**ADDENDUM #2**

<b>Project</b>	TA Blakelock High School Renovations	<b>Project No.</b>	2215-C
<b>Location</b>	1160 Rebecca Street, Oakville, ON	<b>Date of Issue</b>	2025 04 25
<b>Owner</b>	Halton District School Board	<b>File</b>	2215/7.1.3

This Addendum forms part of the Contract Documents and amends the original Drawings and Specifications, dated 2025 04 17, and all preceding Addenda, as noted below.

**A2-1 DRAWING A101 LIBRARY WASHROOMS**

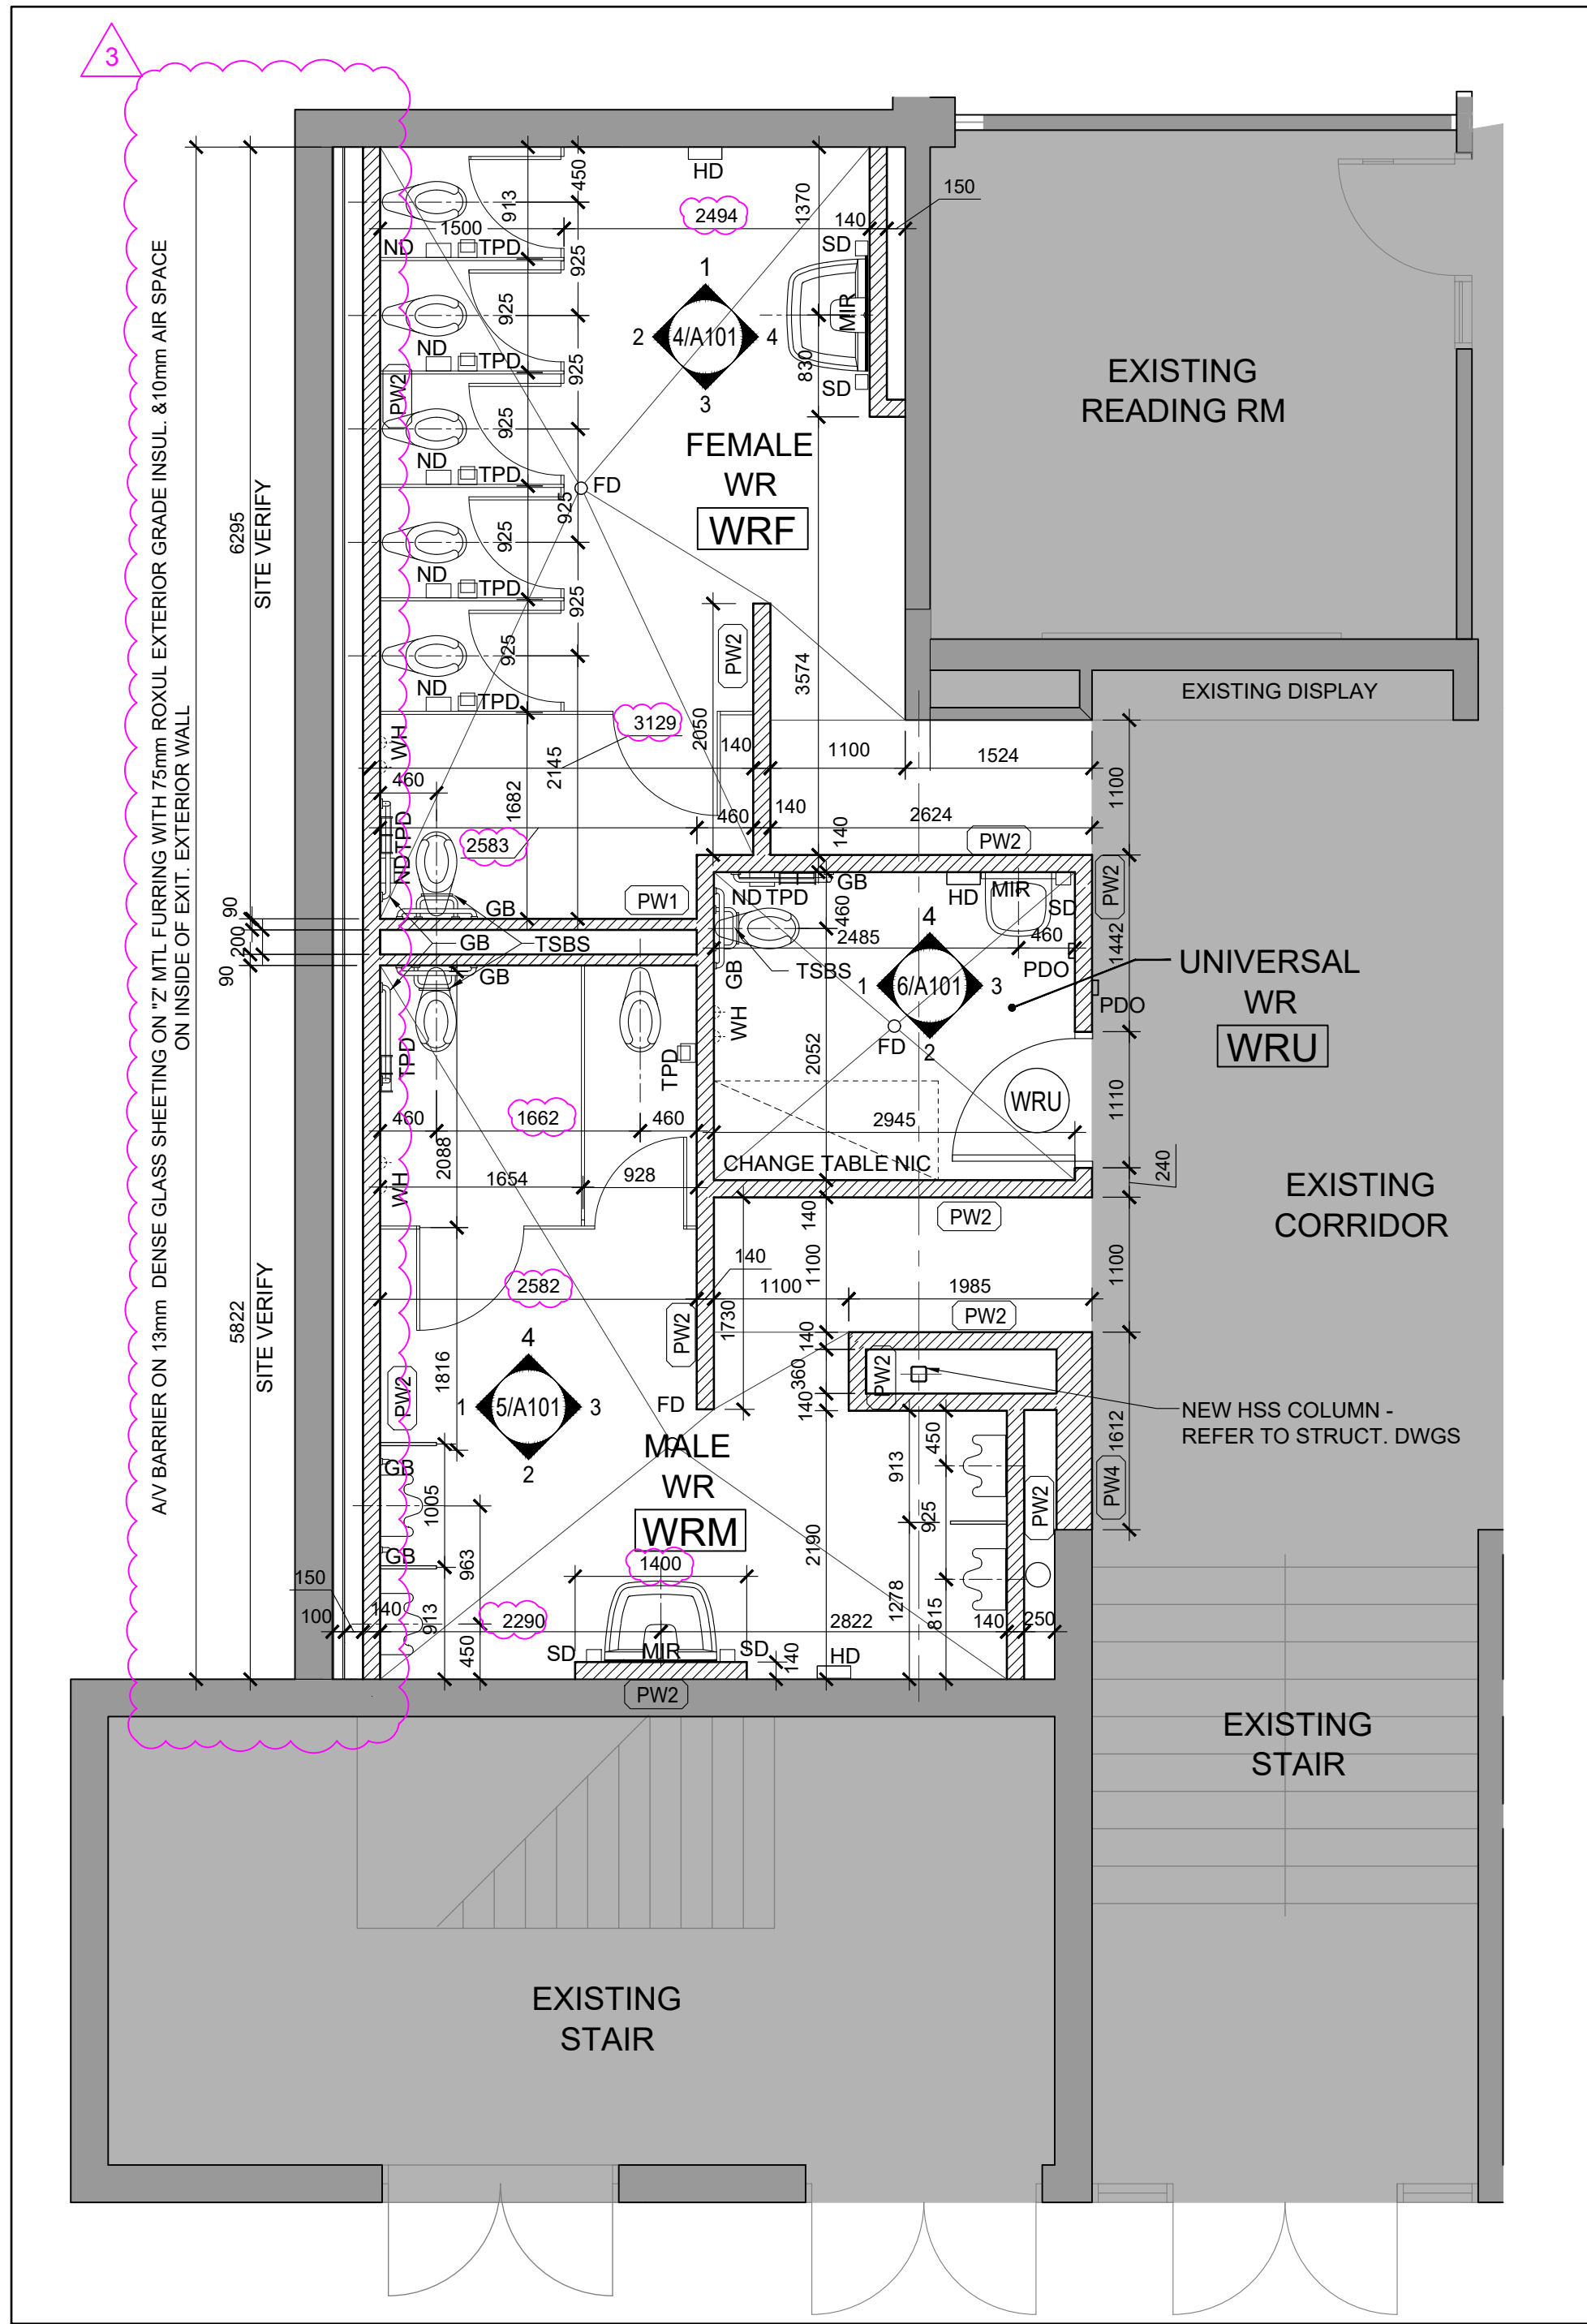
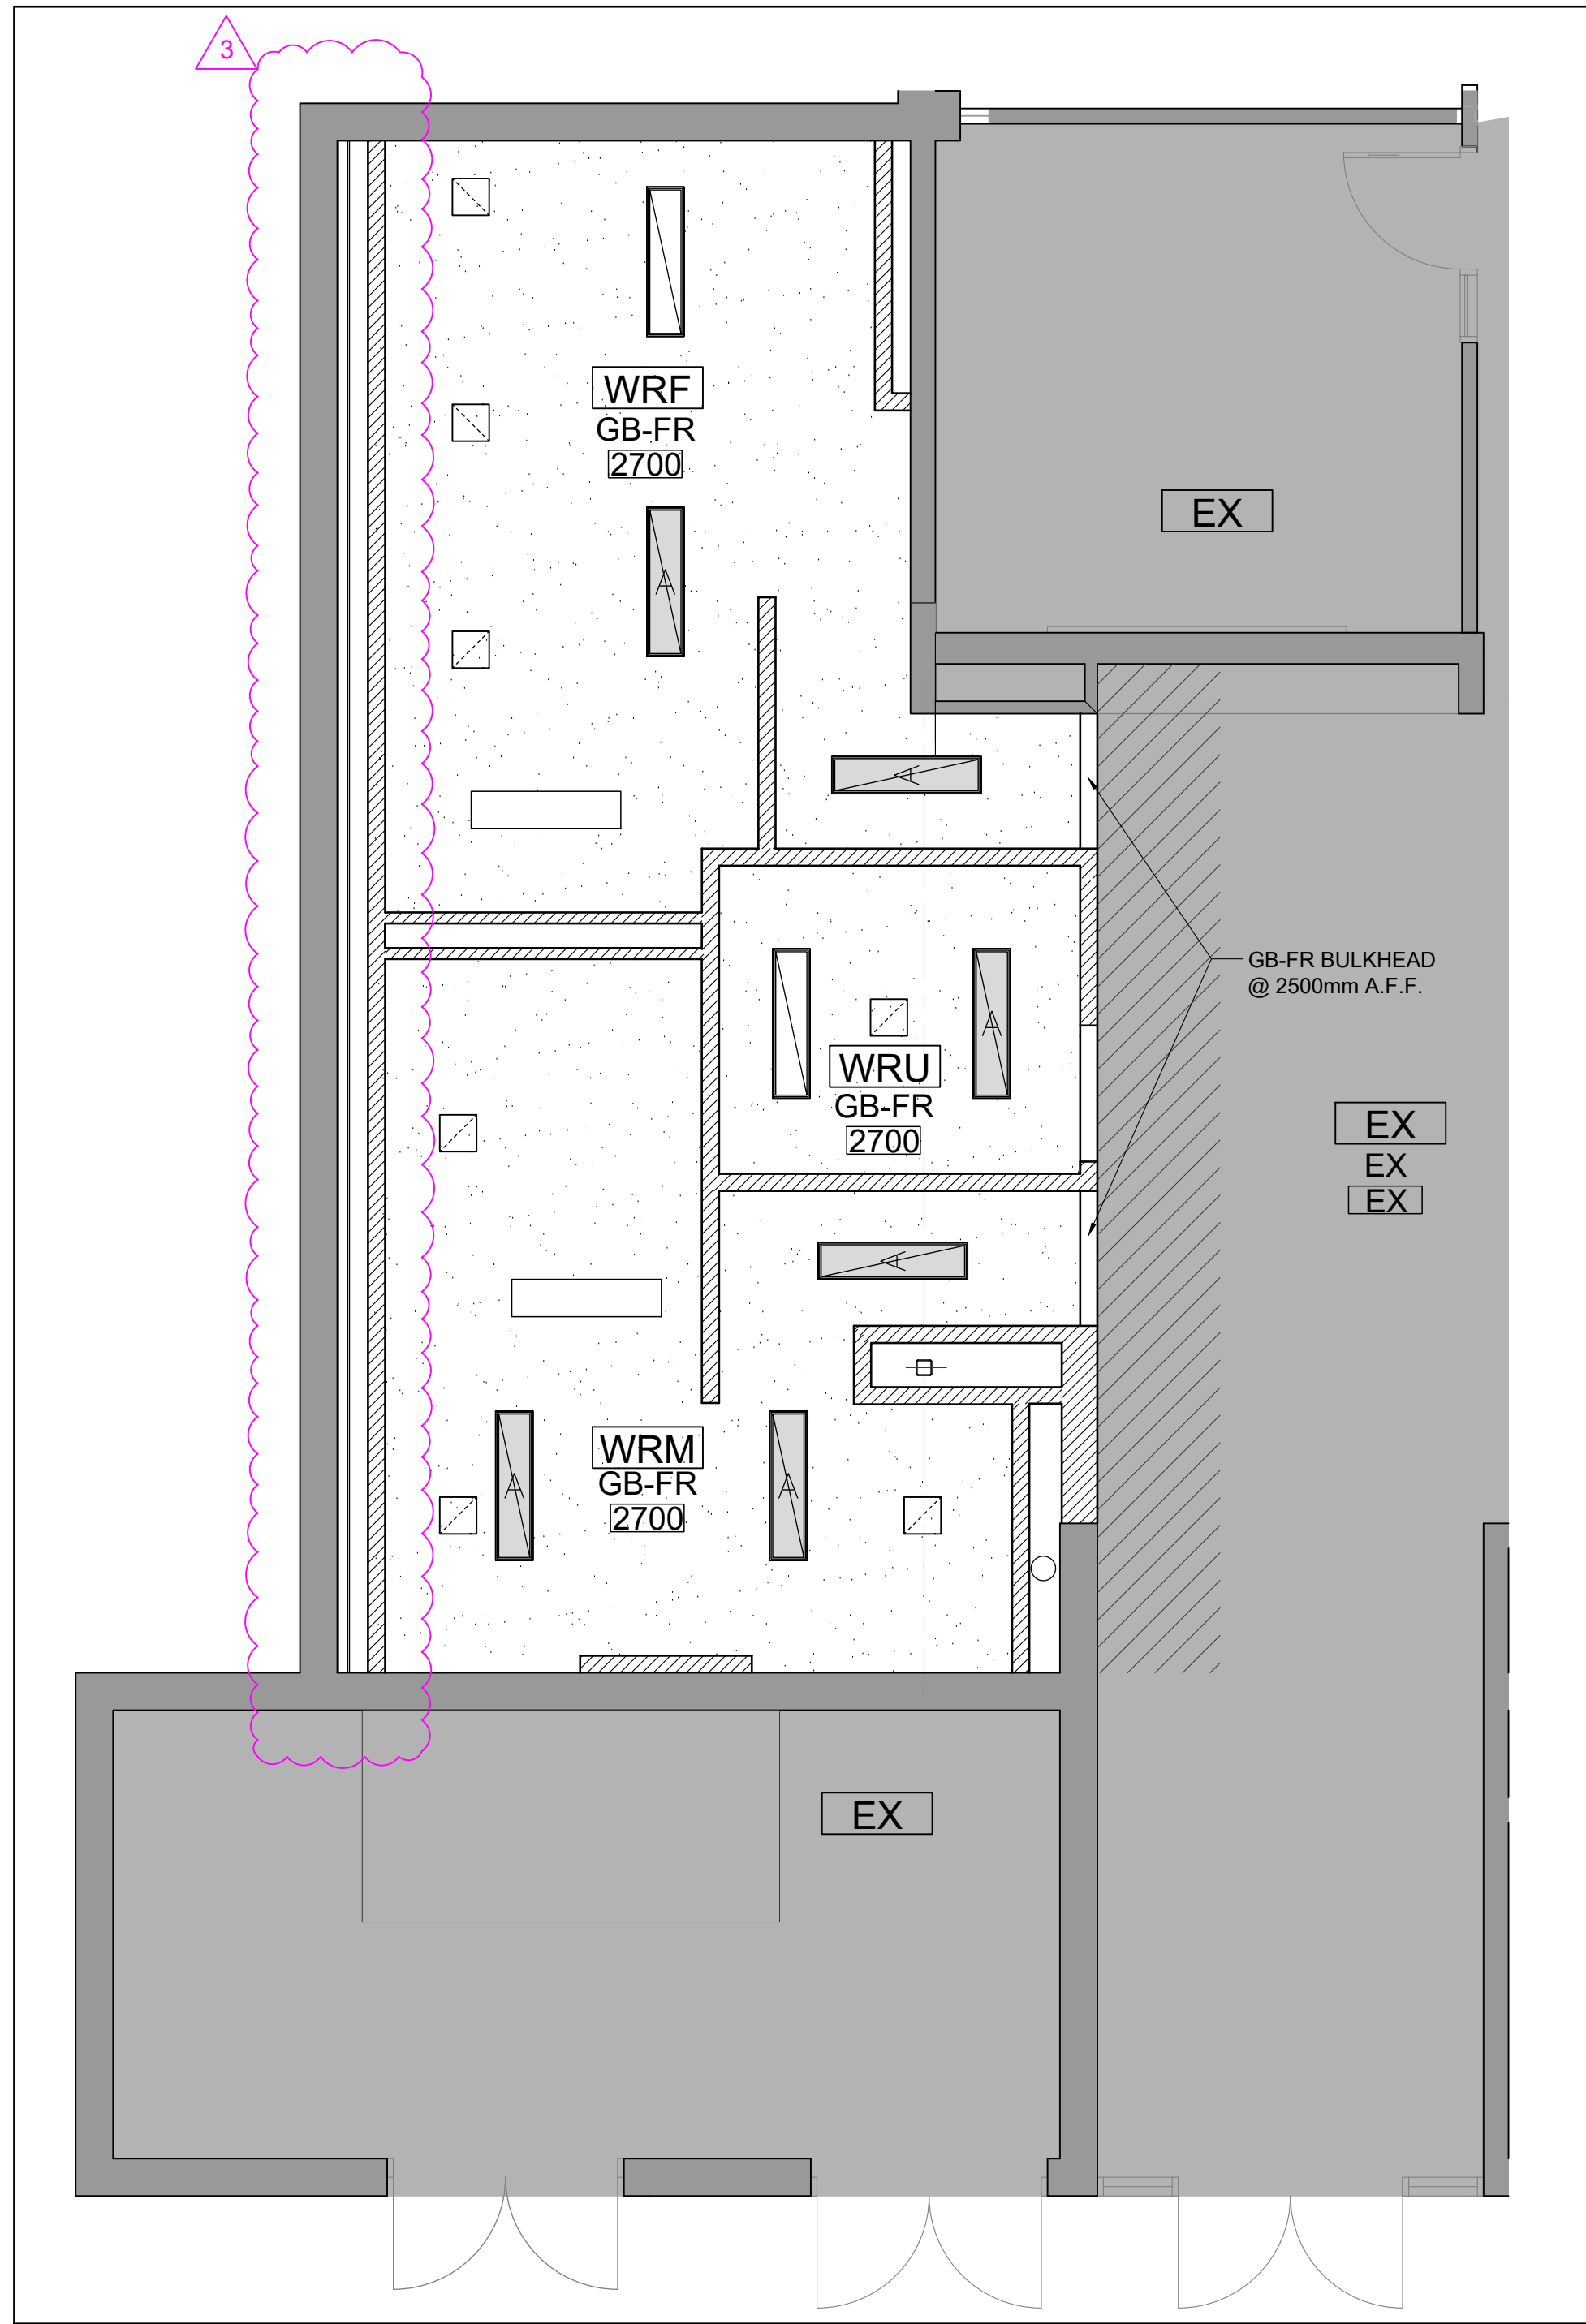
- .1 Interior plumbing wall was shifted to add insulation on the inside of the existing exterior wall.
- .2 Additional notes were added.
- .3 Washroom Accessories Schedule was added to the drawing.
